April 13, 2015

**Subject: Century Tire Plaza – 195 Kennebec Street
Project ID# 2015-027
Review Comments Received April 8, 2015**

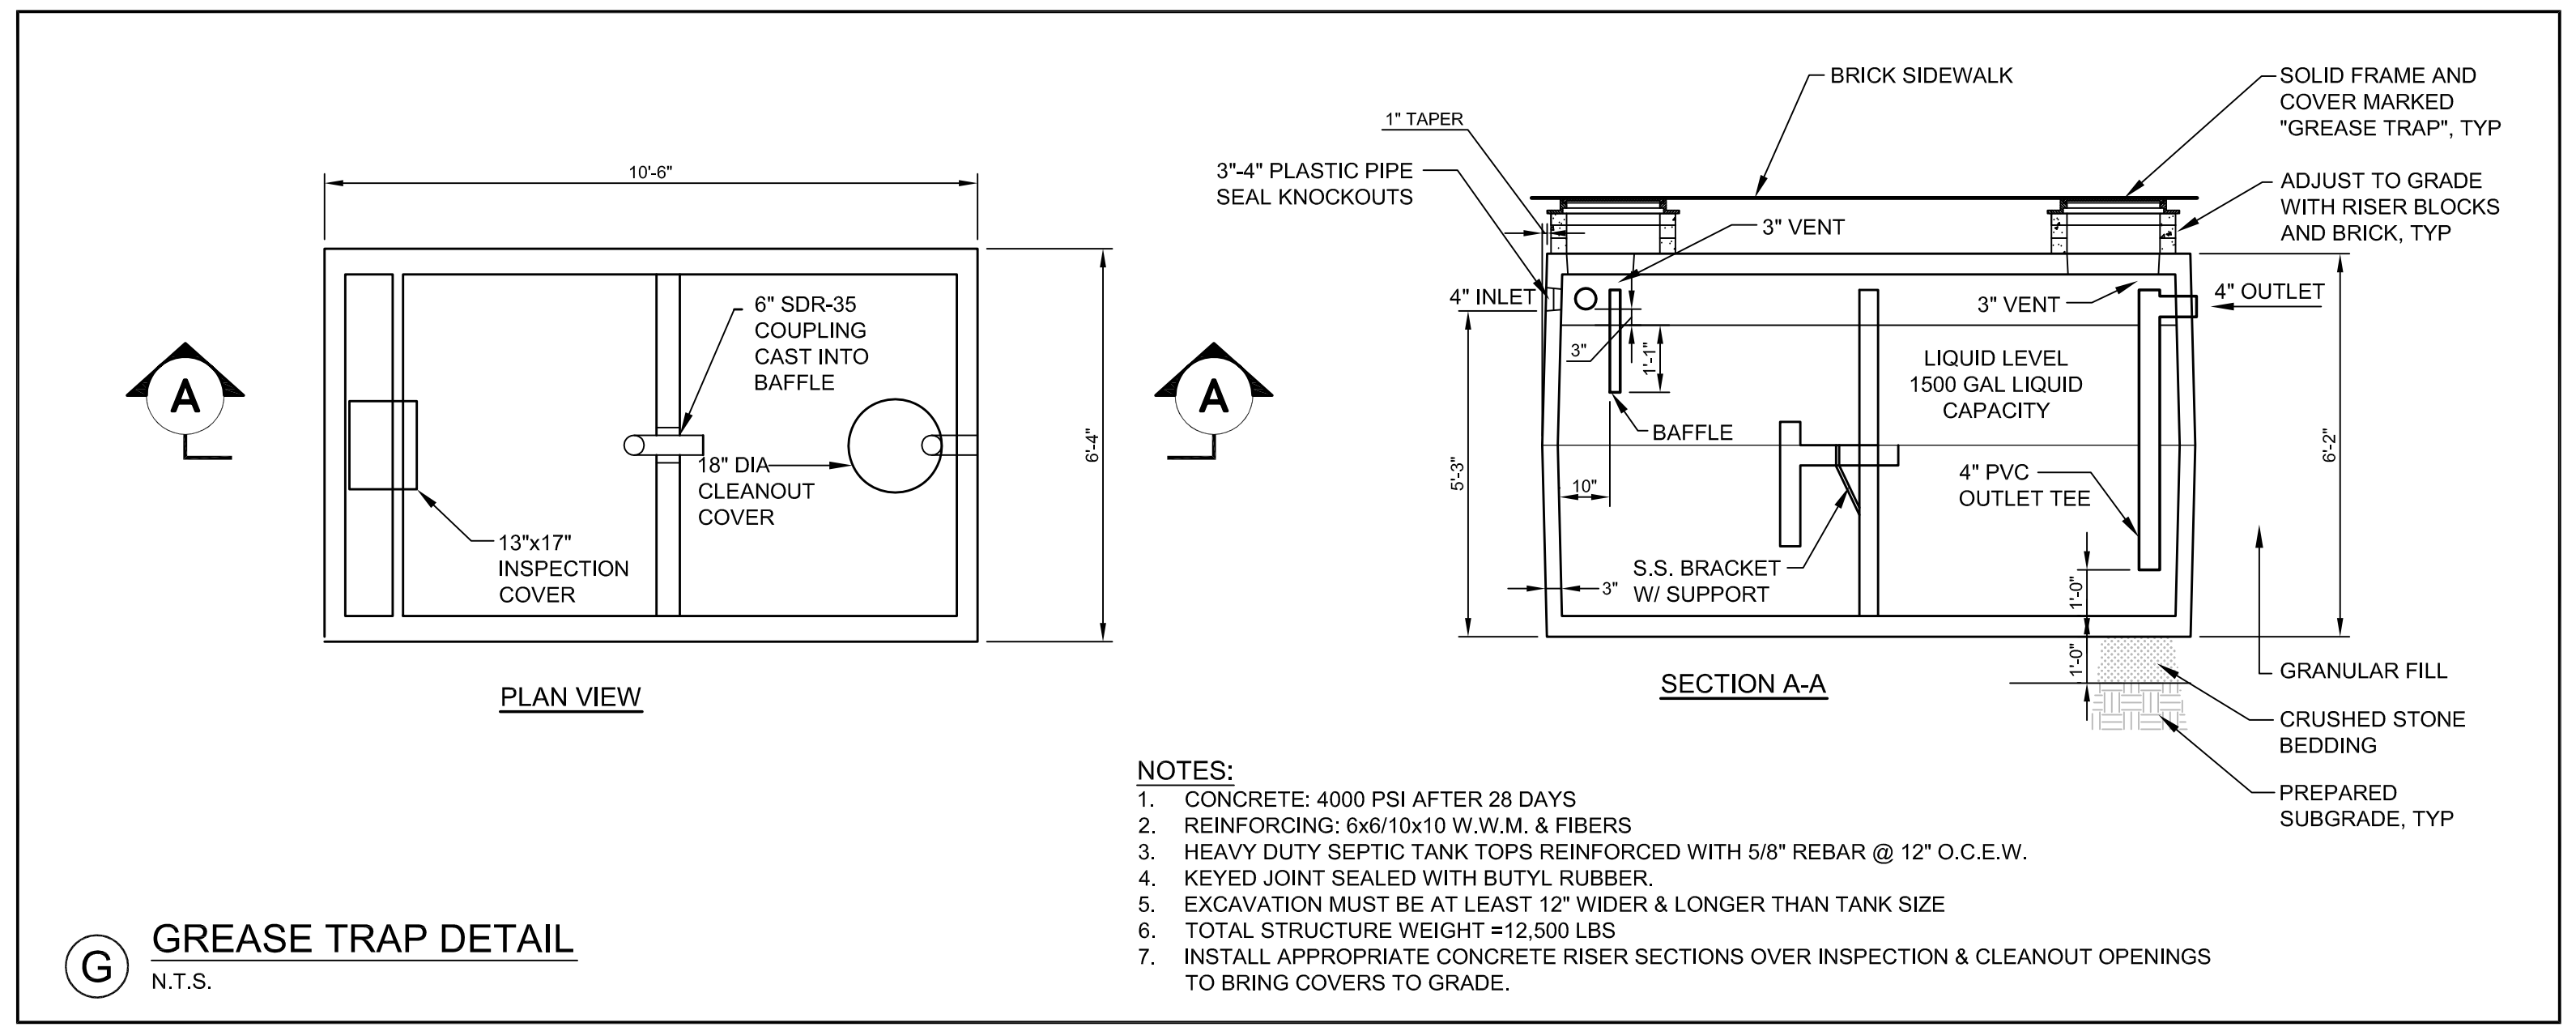
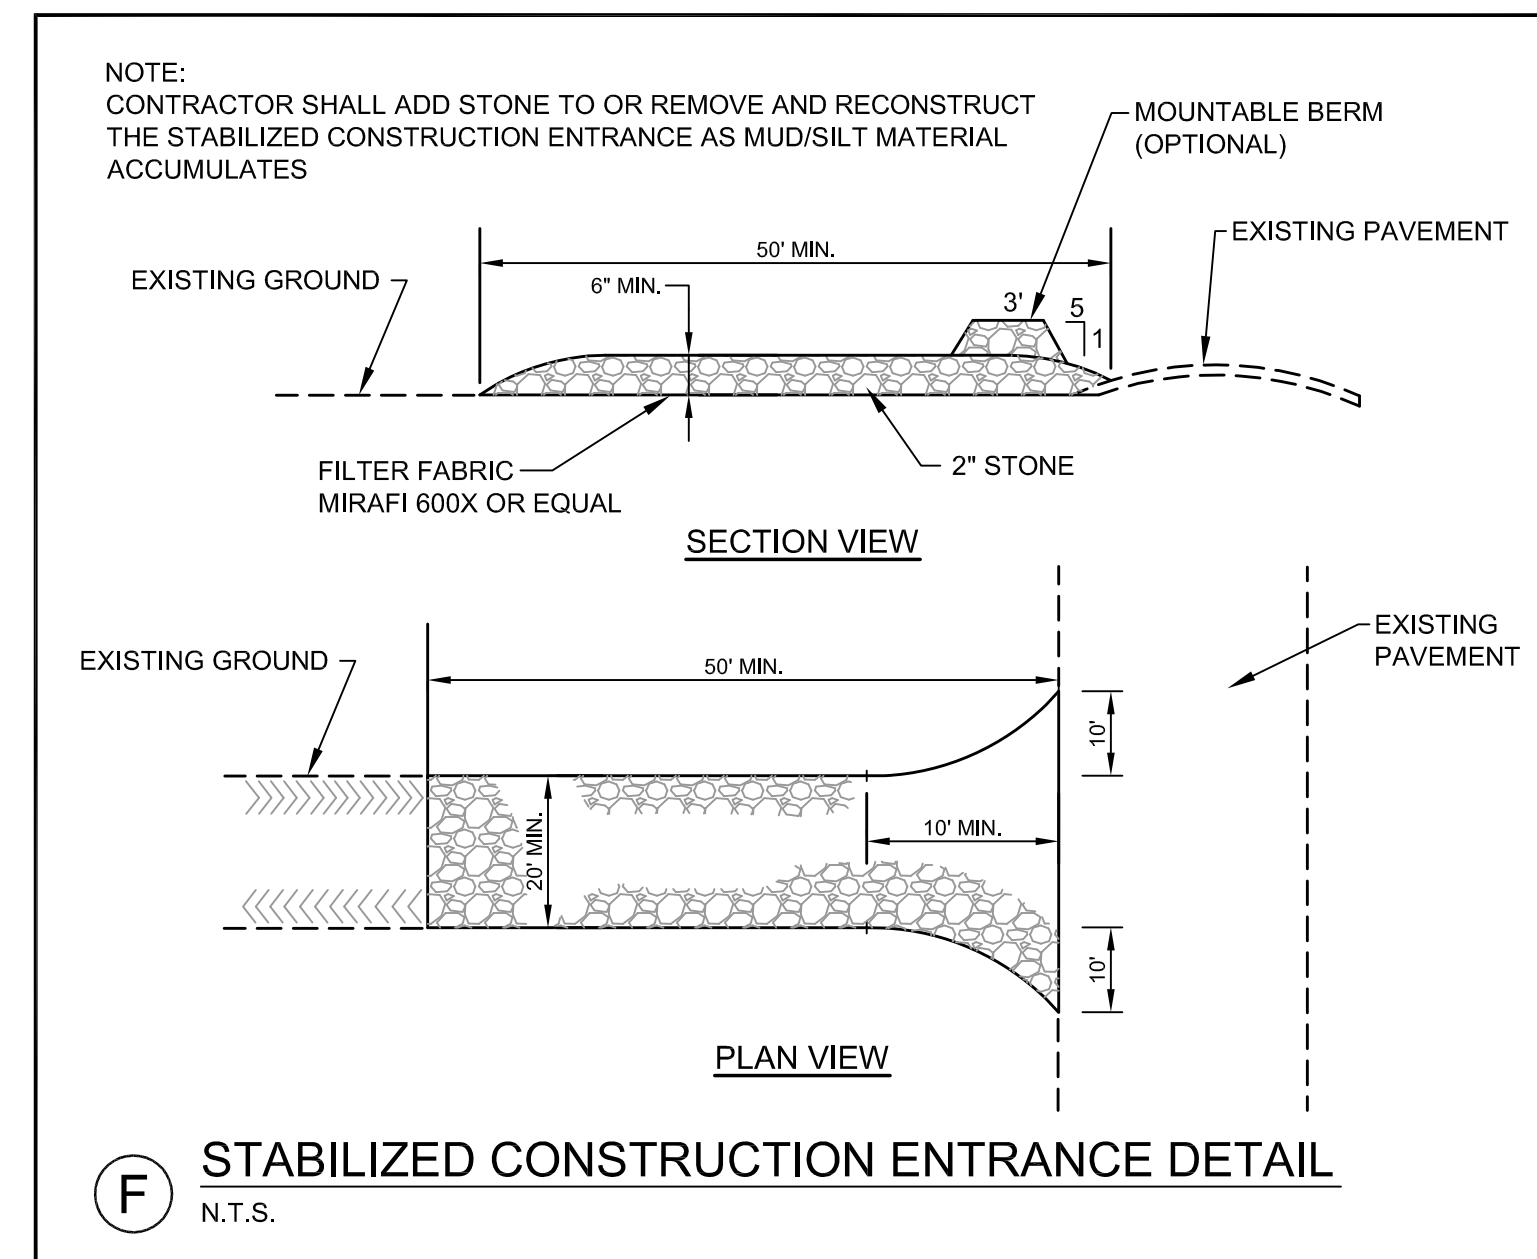
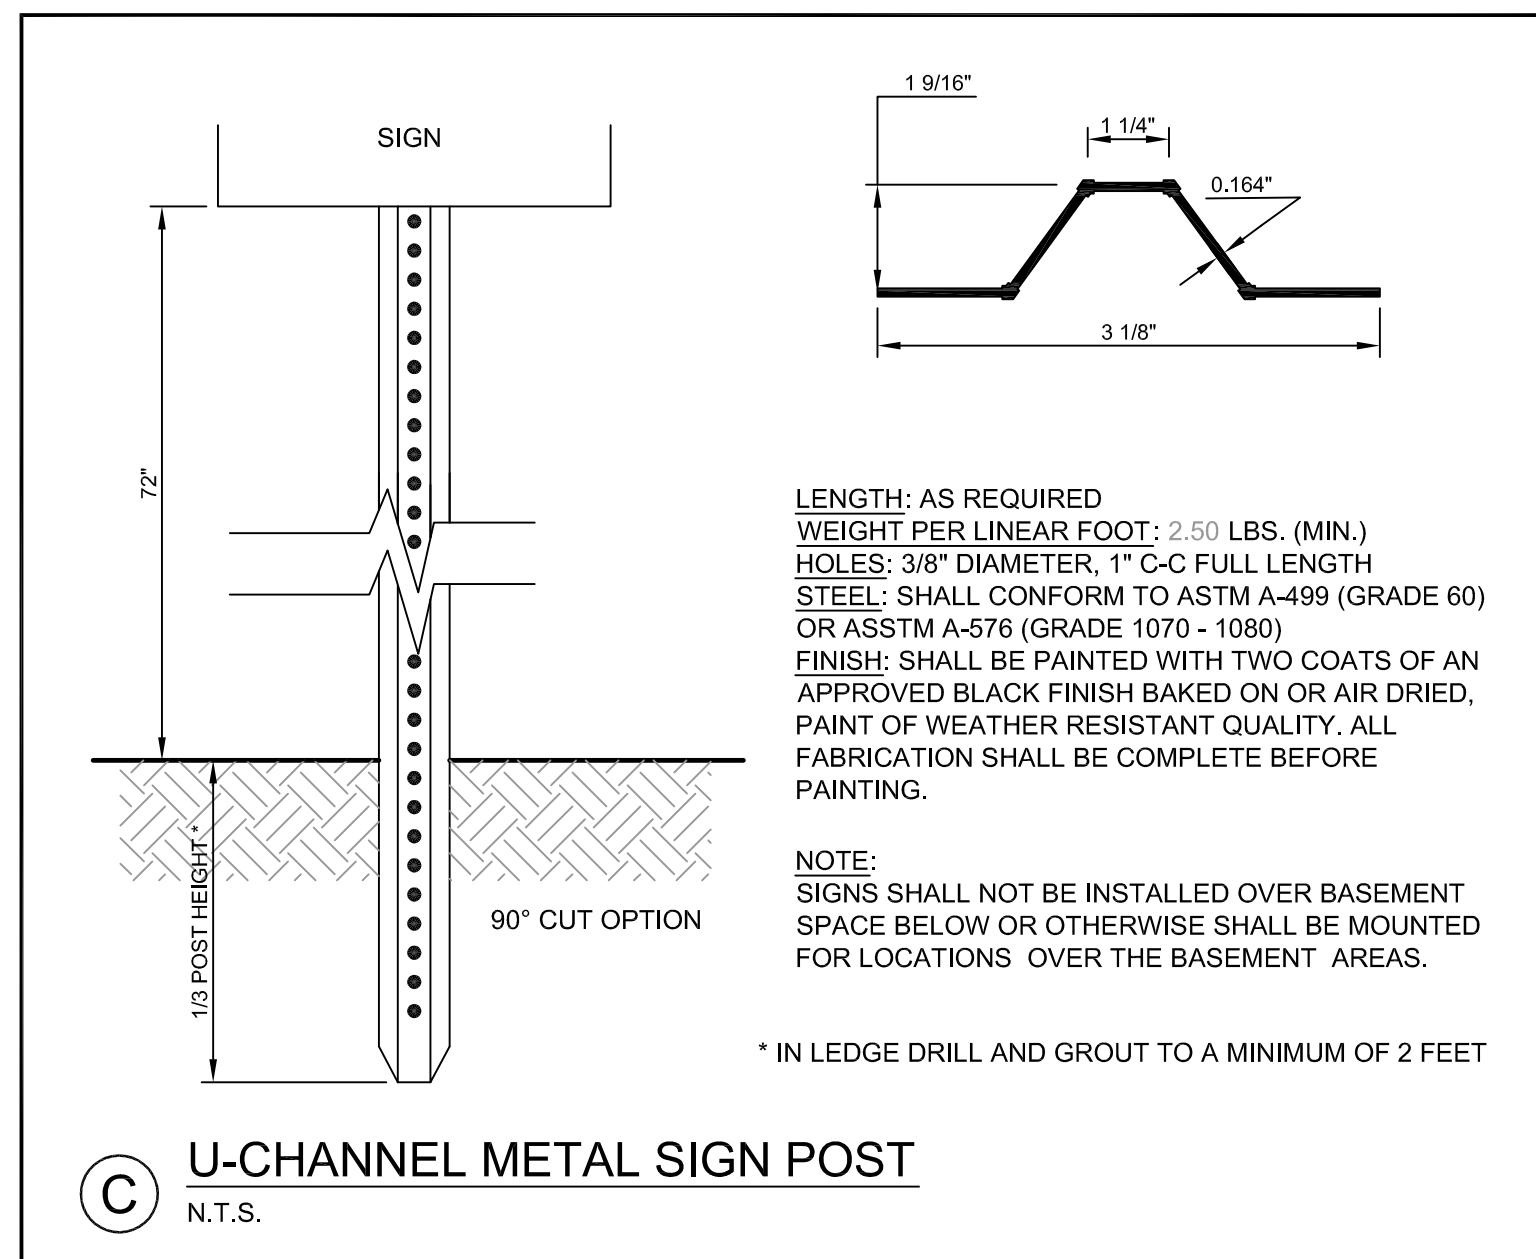
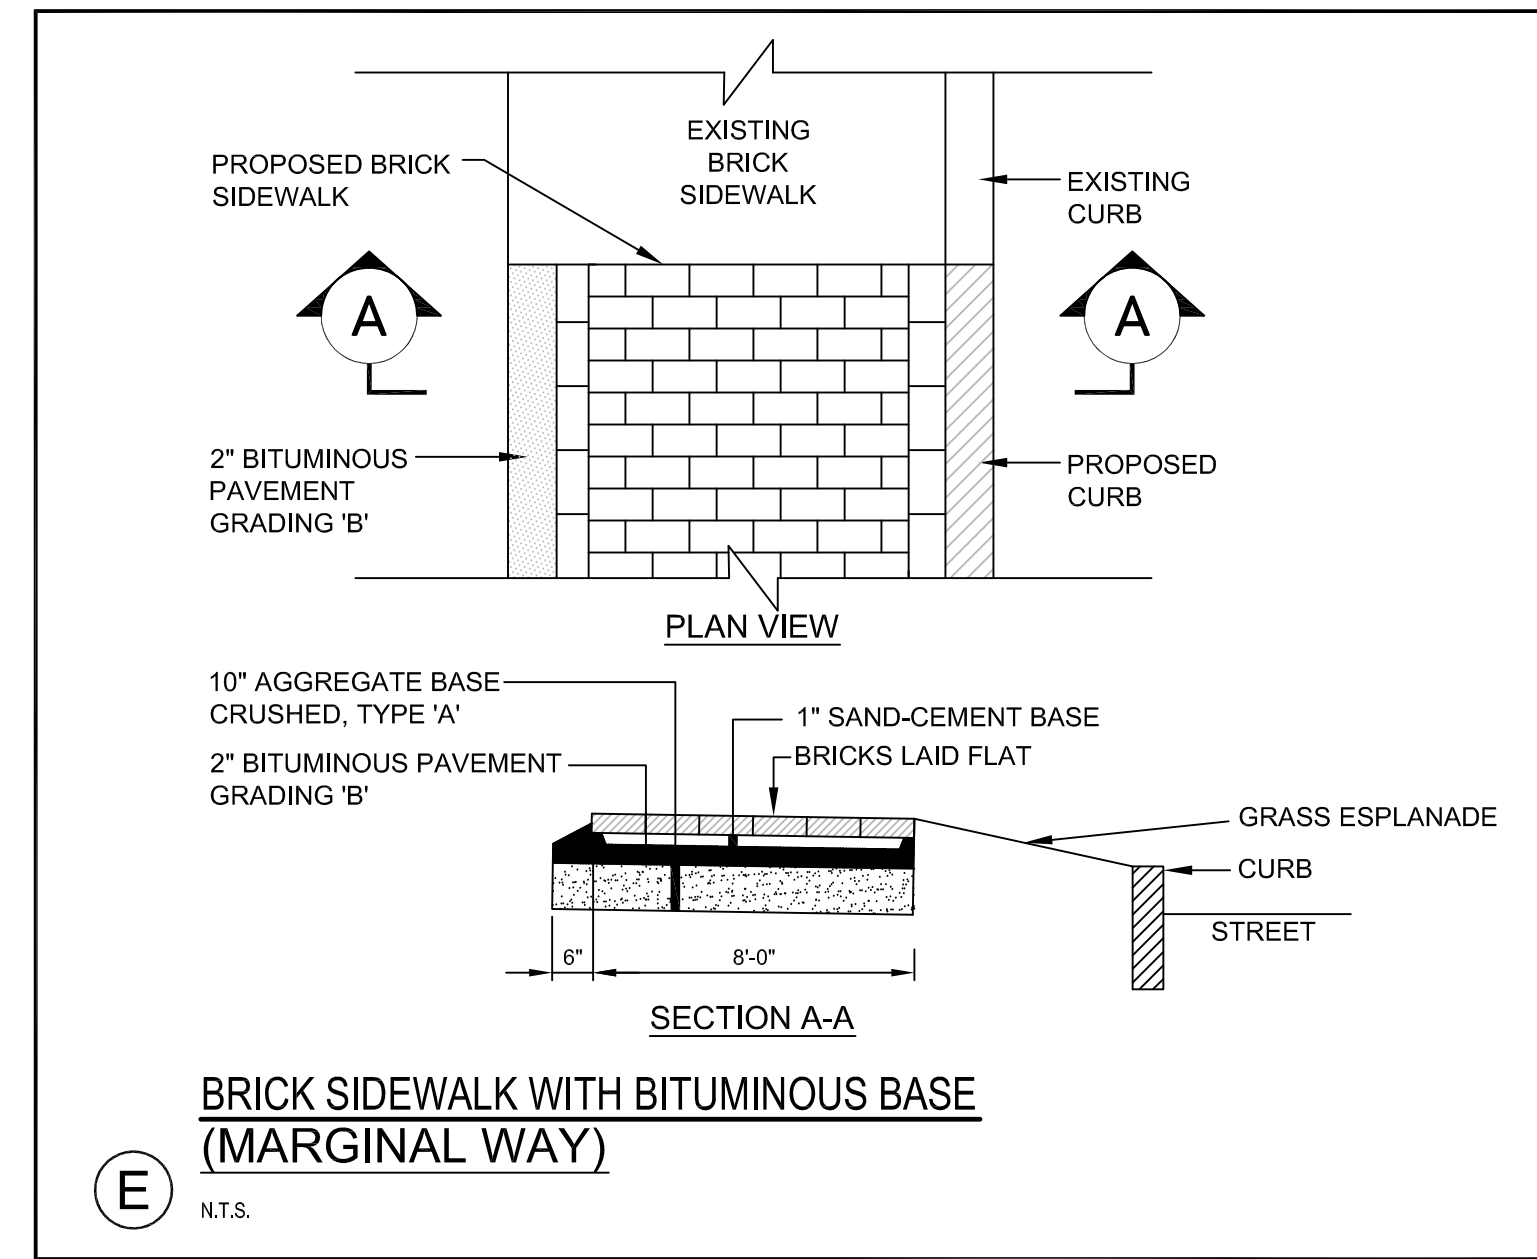
Detail C on plan sheet C-7.0, detail D on sheet C-7.2, and detail E on sheet C-7.2 all should be corrected to show the City standard for depth of base gravel for a brick sidewalk on bituminous base. The depth of gravel should be 10 inches, not 4 inches as indicated in the above referenced details.

The referenced details have been amended on the revised plan sheets to conform to City Standards.
